Charlotte County

23-485, Approve Change Order # 9, East Port Water Reclamation Facility Expansion (Utilities)

**CCU Change Order Request
East Port WRF Expansion - Poole and Kent
Change Order #9**

IR PUMP PLAN AND SECTIONS

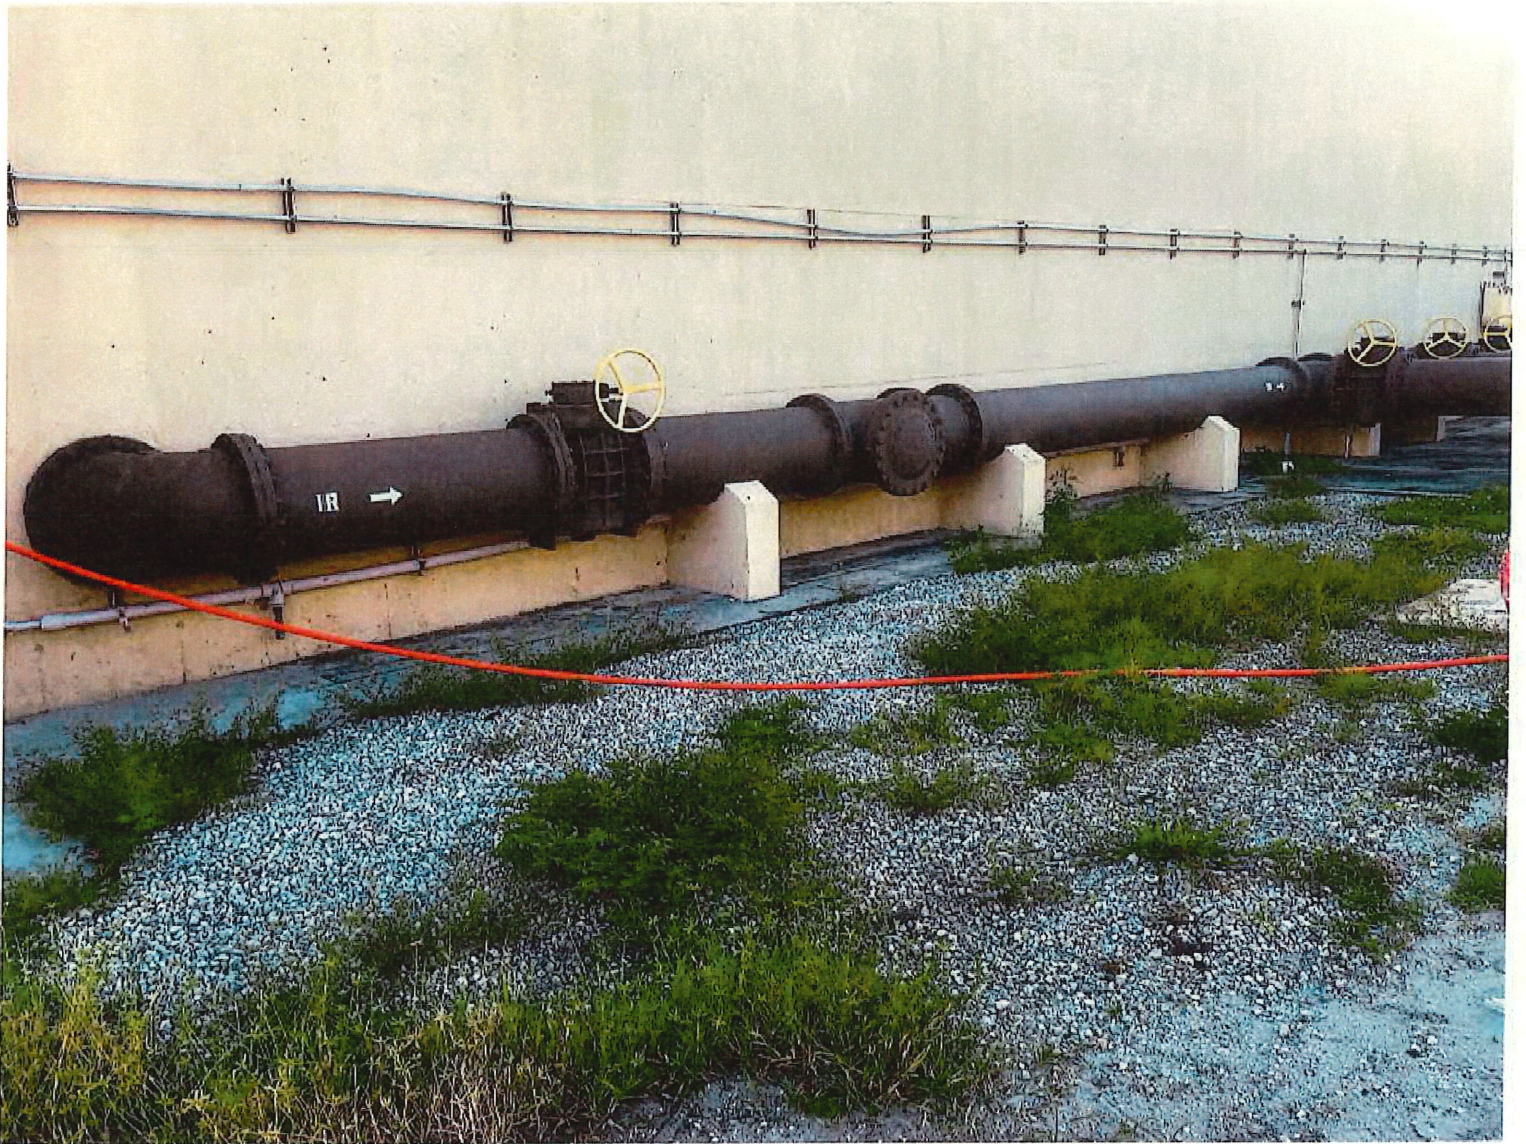
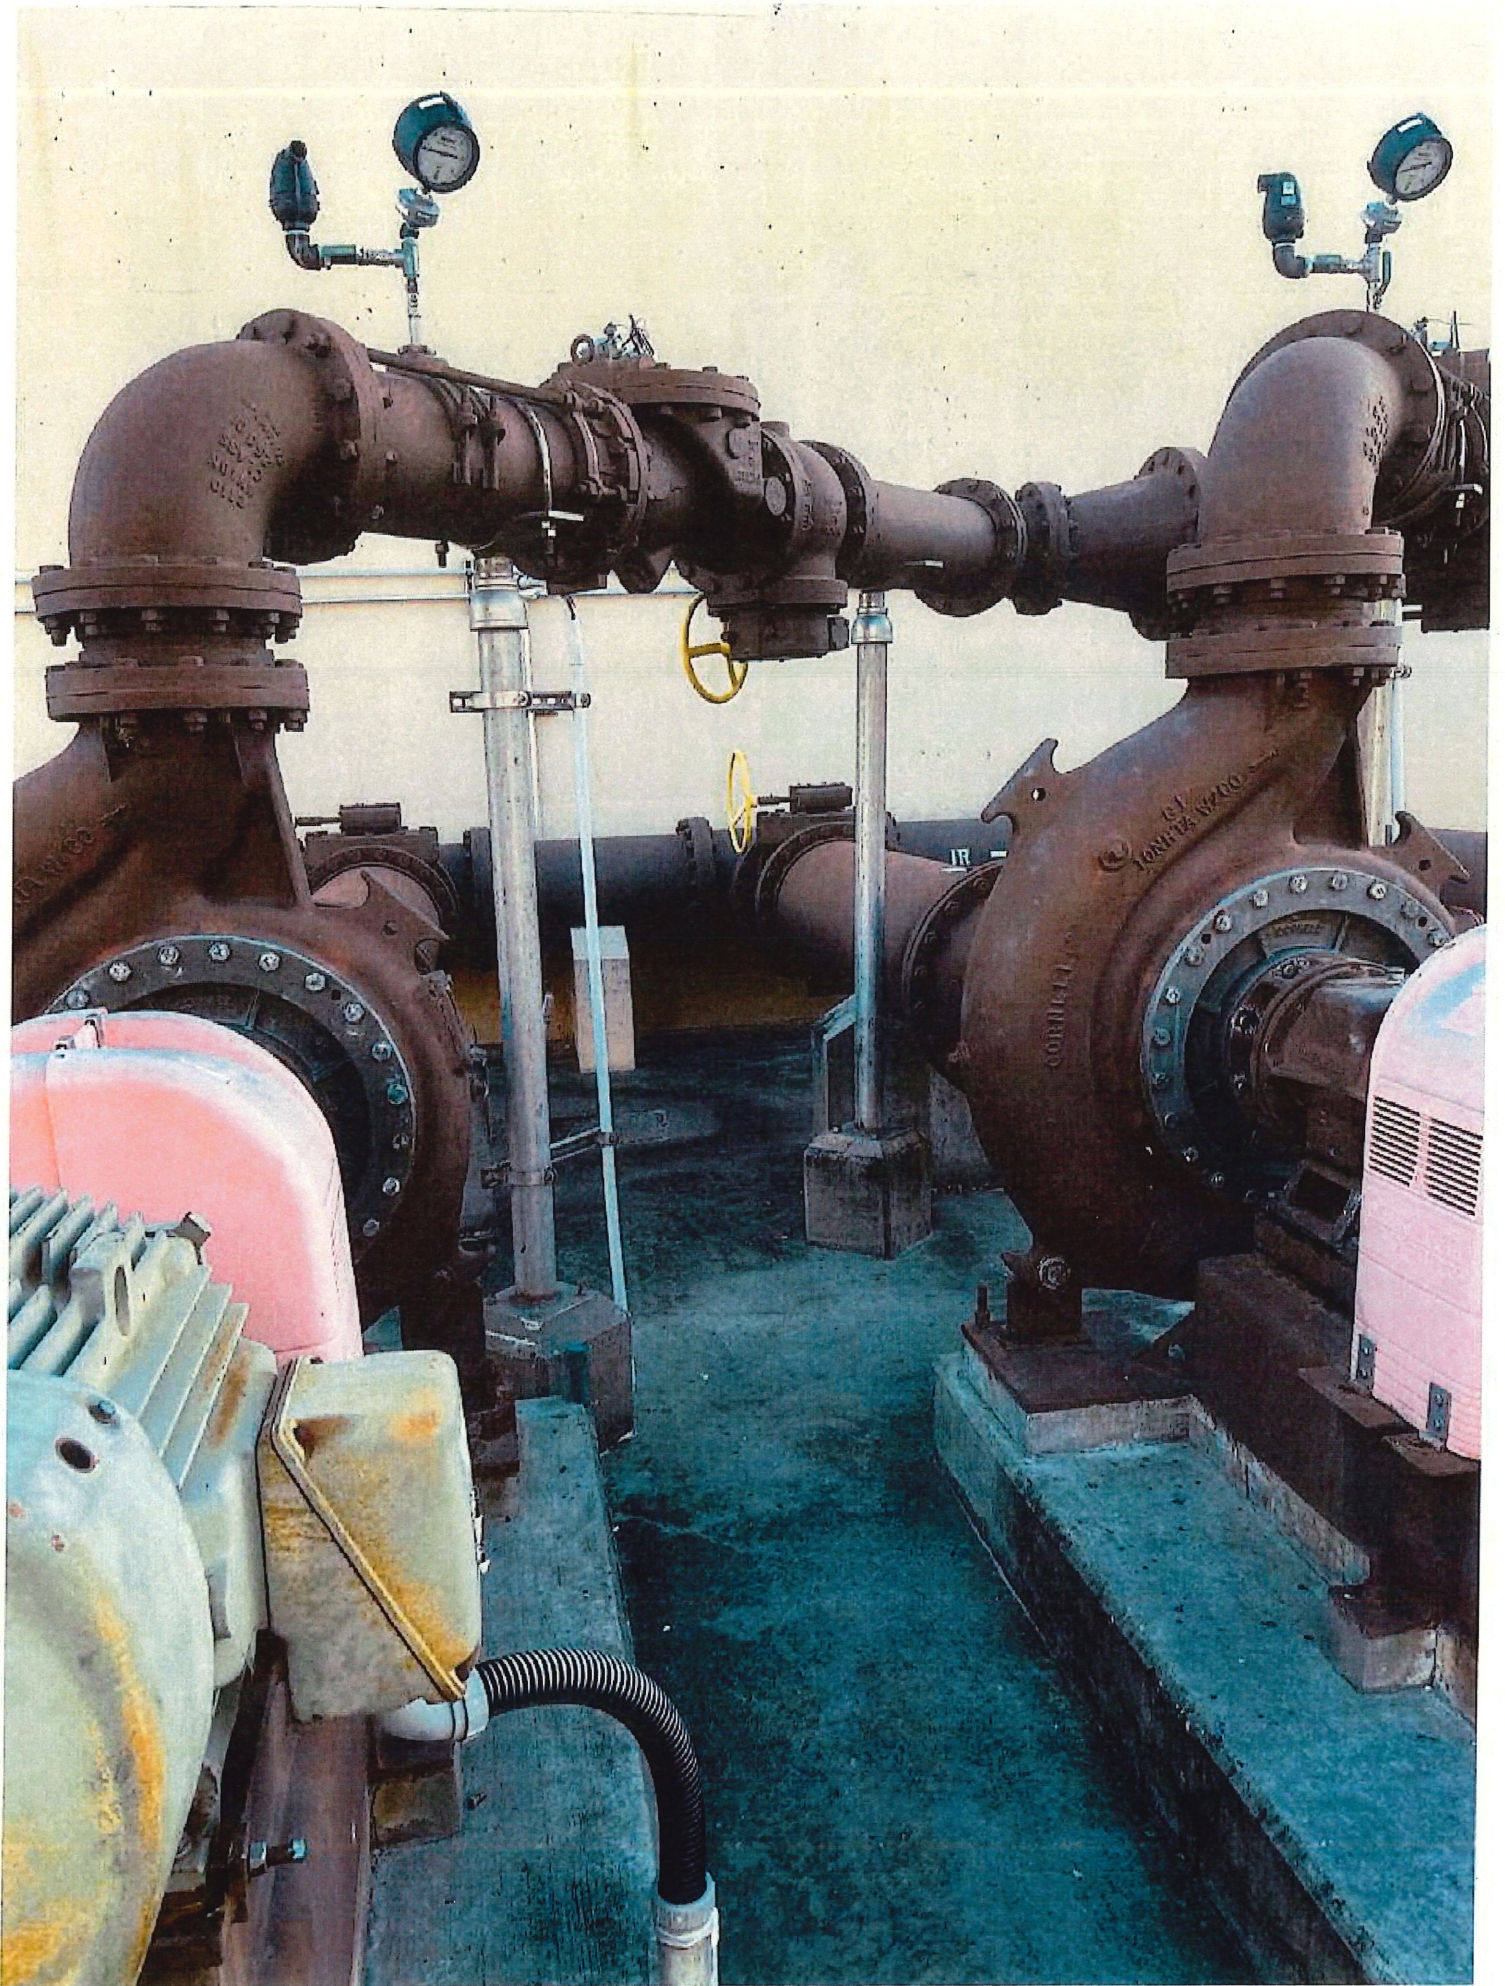
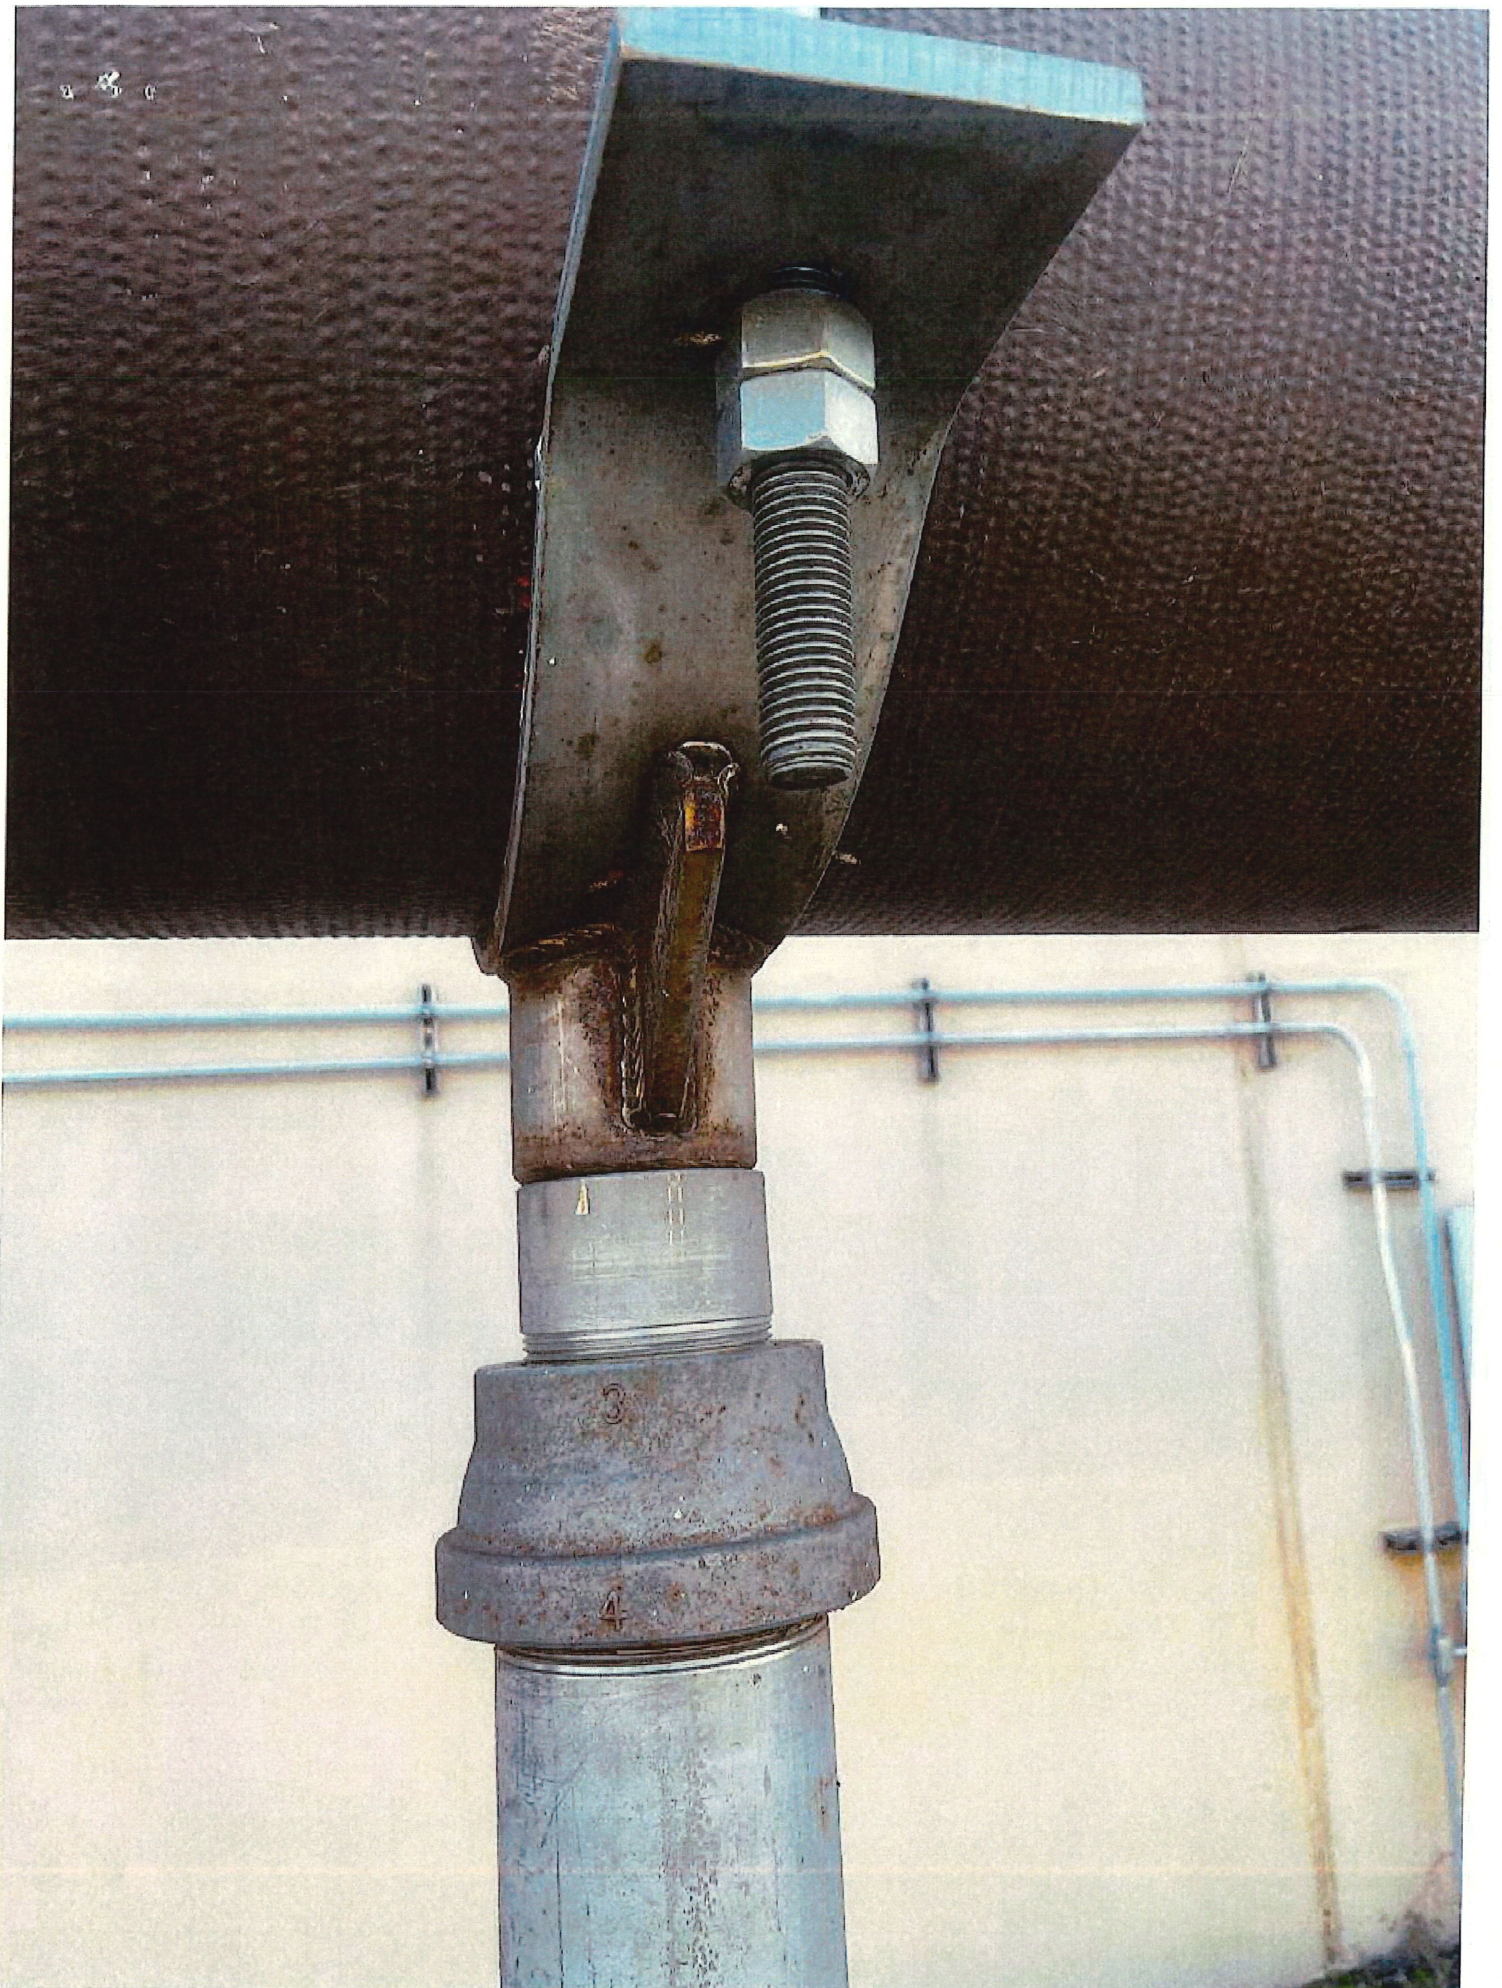
Upon review of contract drawing M32 for the IR pump station, we noticed this drawing does not indicate the quantity or locations of pipe supports. Additionally, the 20" suction piping shown is approximately 5 feet for the north wall of the Oxidation Ditch, but there are no pipe supports depicted or associated concrete base to support this piping. Please review and advise on the quantity and placement locations for the necessary pipe supports. Once received, P&K will prepare a cost estimate to supply and install this material accordingly.

1. Please review the attached markup drawing and photos. Furnish and install to match the existing match type, size, and material as per the detail drawings M-75 and M-76.

July 16, 2025, Jones Edmunds (JE) issued a fully executed response to **RFI #141**, providing a marked-up drawing and reference photos and directing P&K to furnish and install pipe supports to match the existing type, size, and material in accordance with **Detail Drawings M-75 and M-76**.

MISCELLANEOUS SLABS

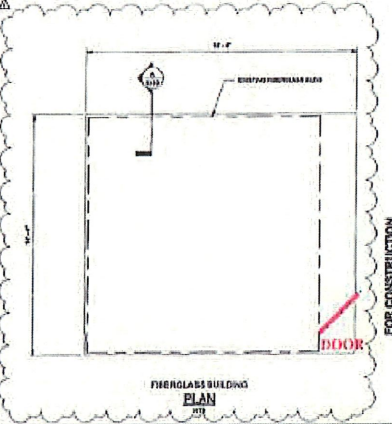
Rebar details for the pads to include double #5 rebar per detail with 2" clearances on sides

HEADWORKS FLOW SPLITTER BOX -
 LOWER AND INTERMEDIATE PLAN

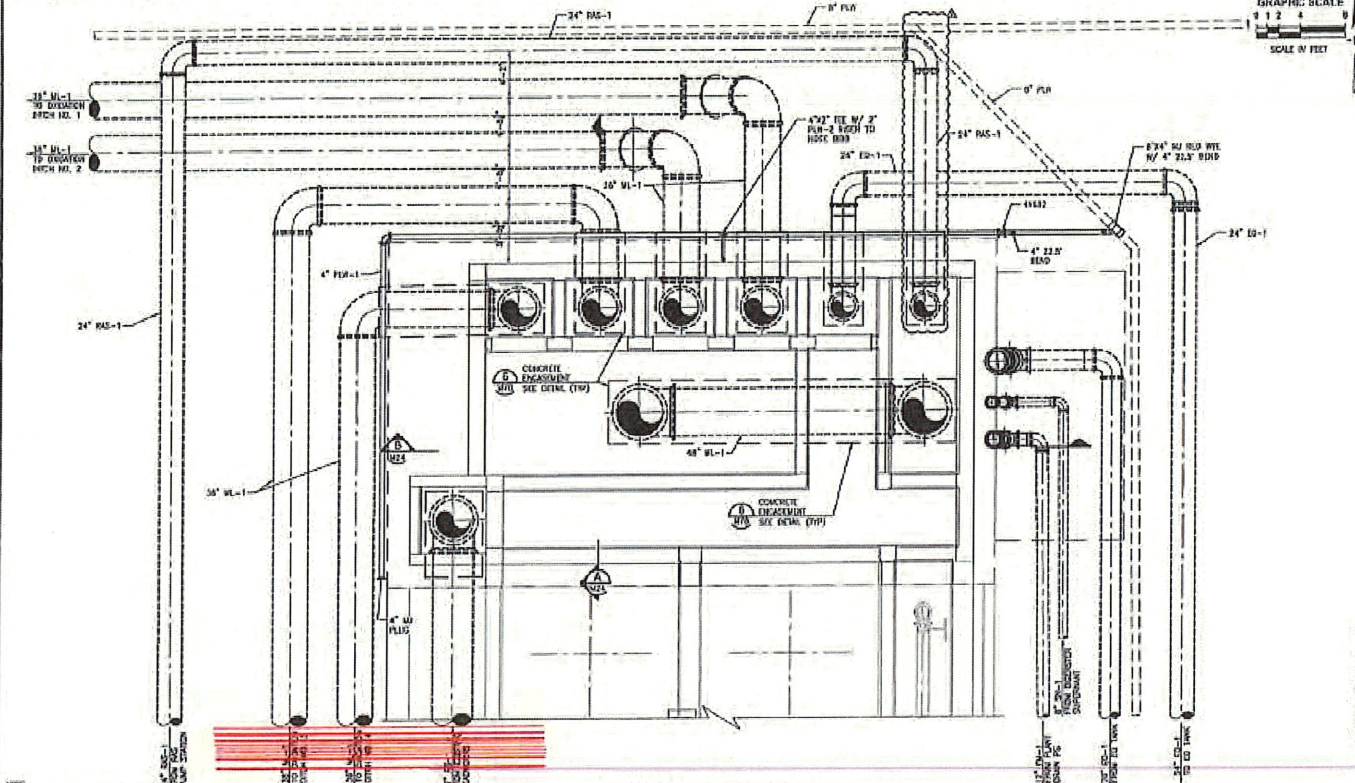
August 29, 2025, Poole & Kent (P&K) encountered an unforeseen underground condition during excavation for the installation of two (2) 36-inch ML pipelines and one (1) 42-inch RS pipeline extending from the Headworks Splitter Box (HWSB). P&K promptly notified the Owner and Engineer by submitting **RFI #161**, reporting the discovery of a previously unidentified duct bank consisting of approximately twenty (20) conduits ranging from 1 inch to 3 inches in diameter located directly at the required pipe elevation. This condition conflicted with all three remaining pipeline installations and resulted in a complete work stoppage in the affected area. P&K requested direction regarding identification of active, future, and abandoned conduits and instructions on how to proceed.

is Described Below or in the Attached: The County has directed Poole & Kent to proceed under Time & Materials basis to identify these conduits and any live circuits.

SECTION B
1/4"-1'-0"

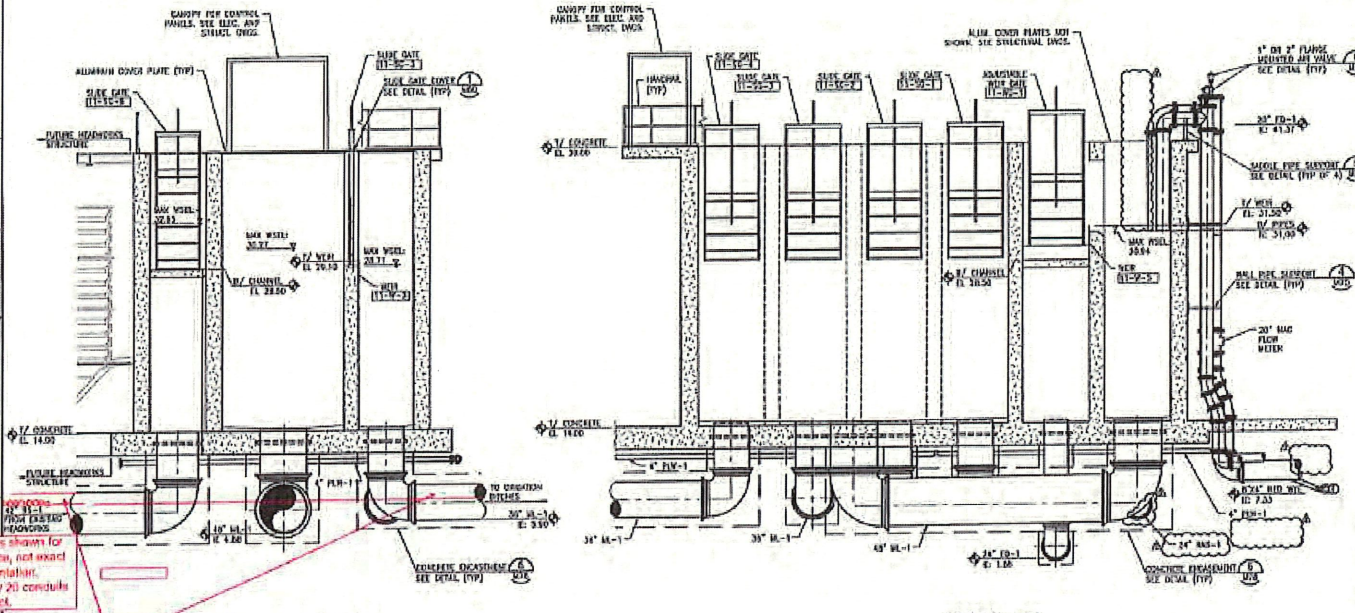
Conduits shown for reference, not exact representation. Roughly 20 conduits in conflict.
